DEVELOPMENT REVIEW COMMITTEE
Meeting Date: MARCH 16, 2022

APPLICANT RESPONSES

IDI LOGISTICS LUPA

Request: Local Only LUPA
P&Z# 22-92000001

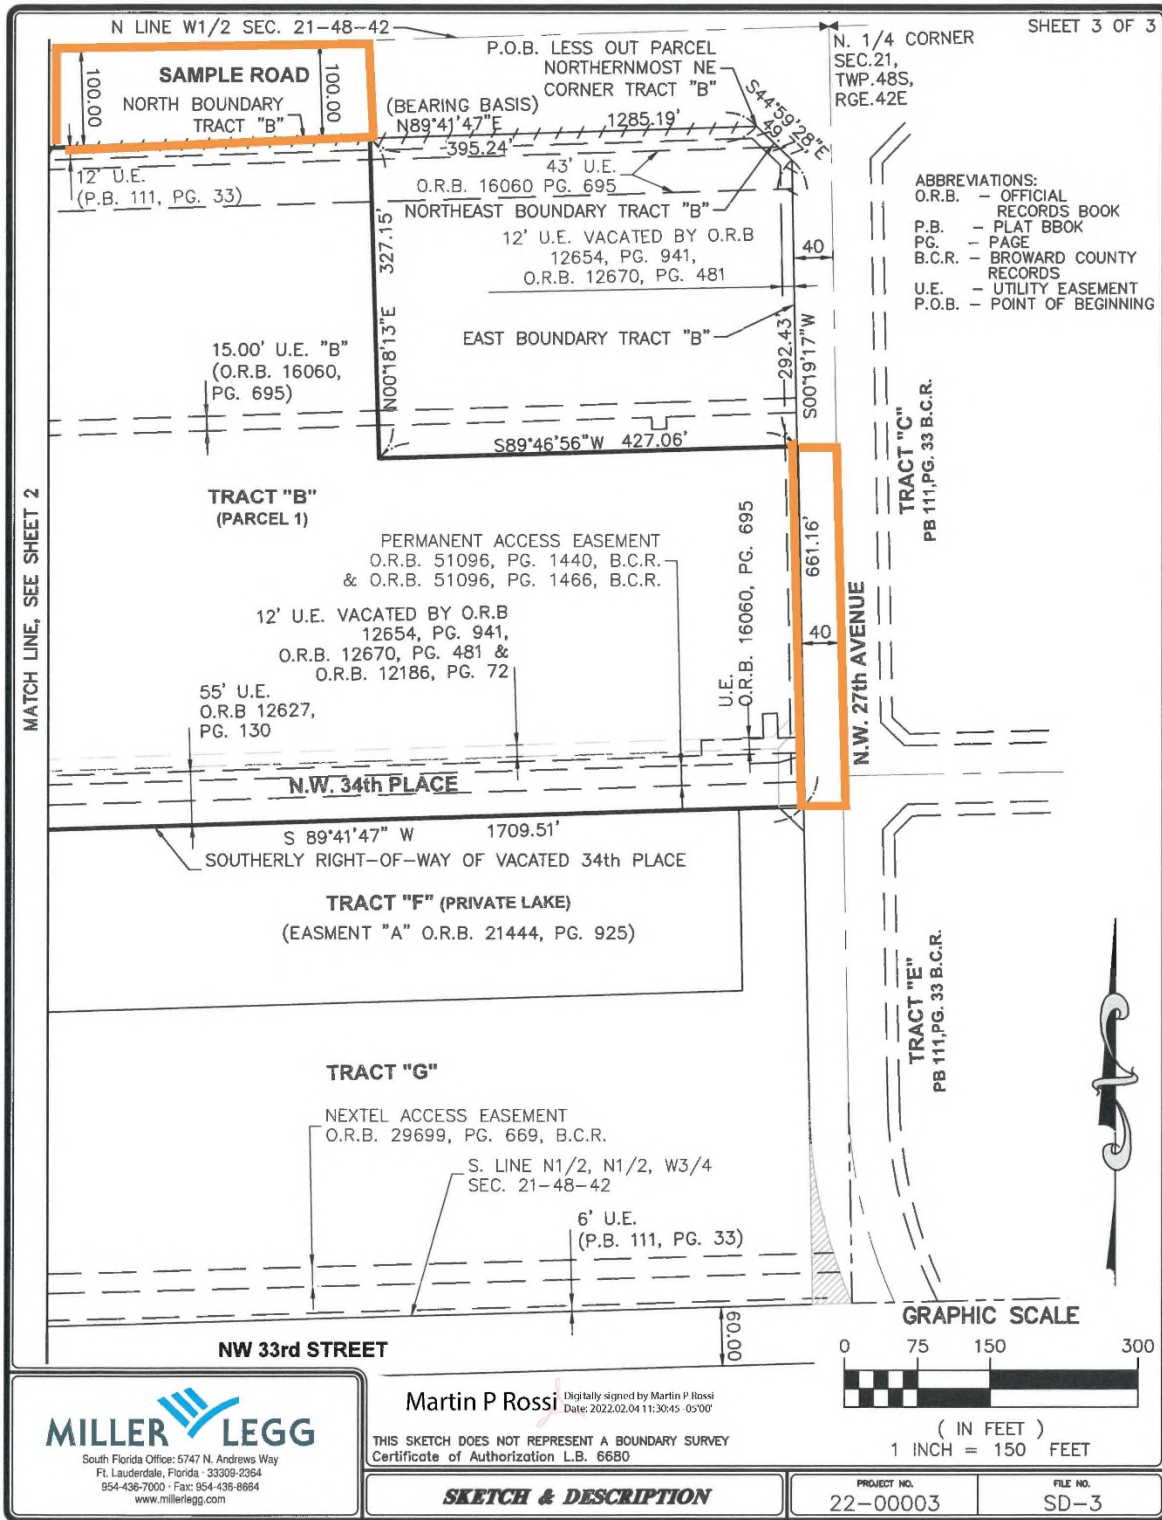
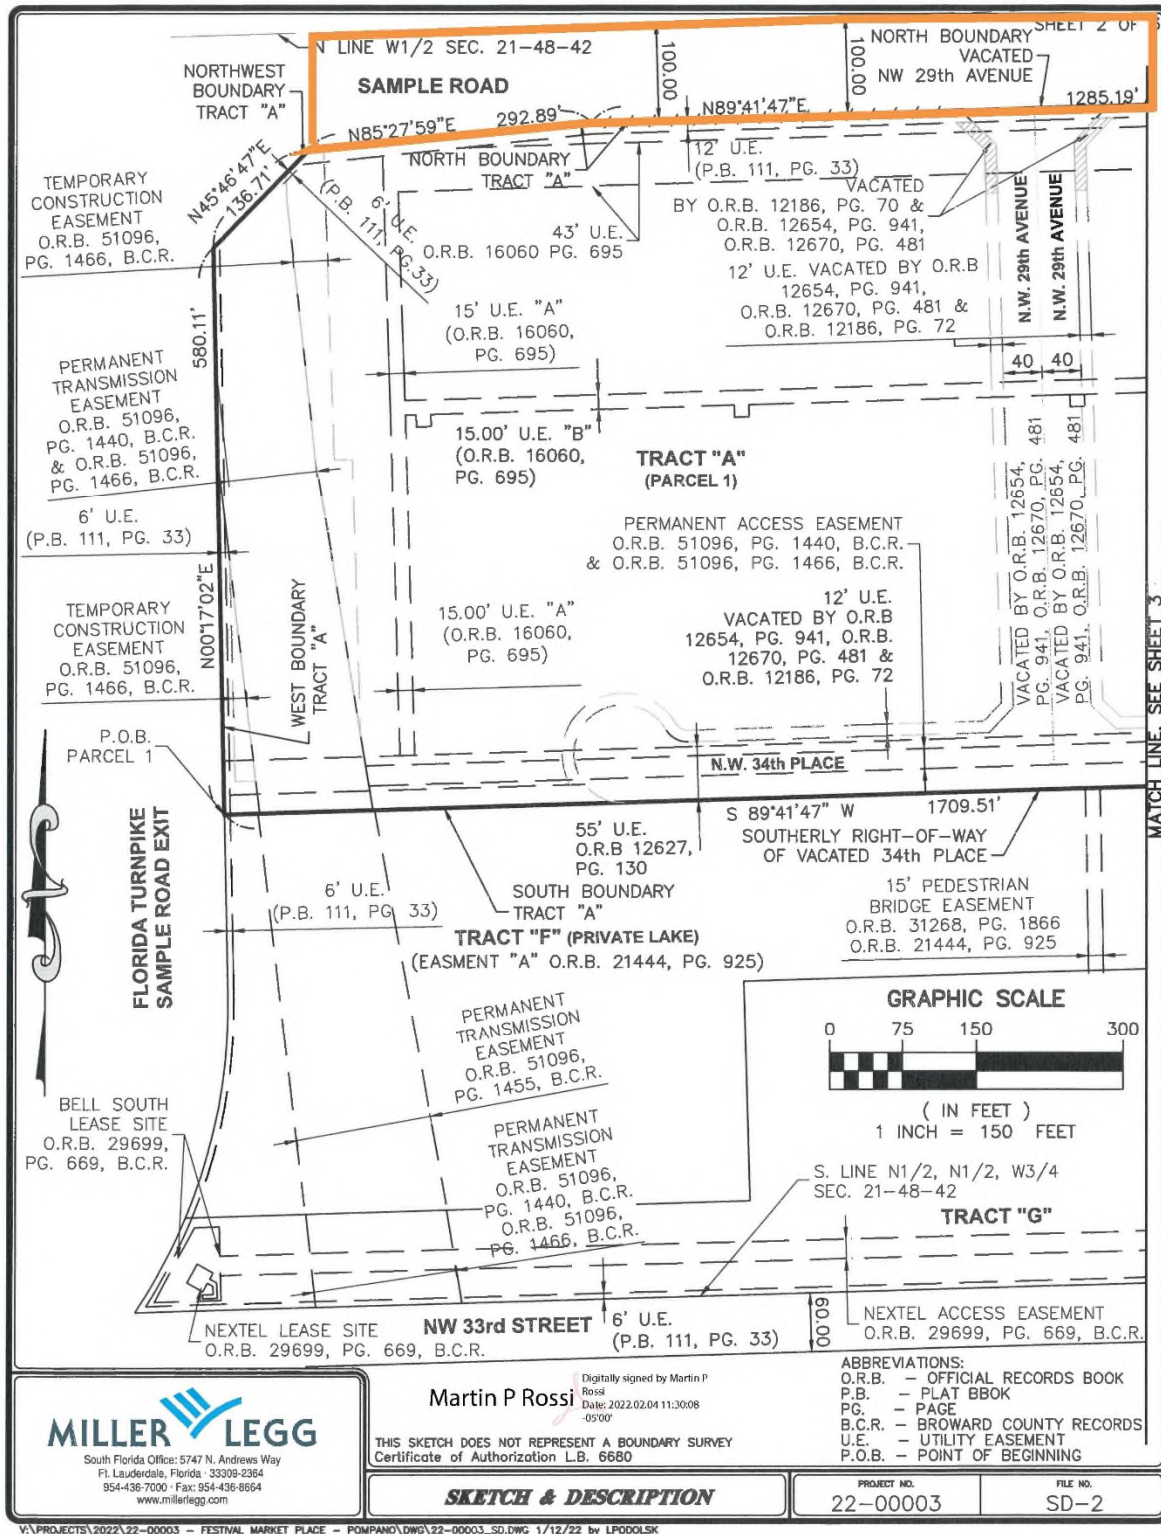
16. It would be appreciated if we have a legal description in Exhibit A which showed the Gross Acreage and showed the land area used in that calculation.

Response: The areas included in the gross acreage figure are noted in orange on the attached sketch and legal.
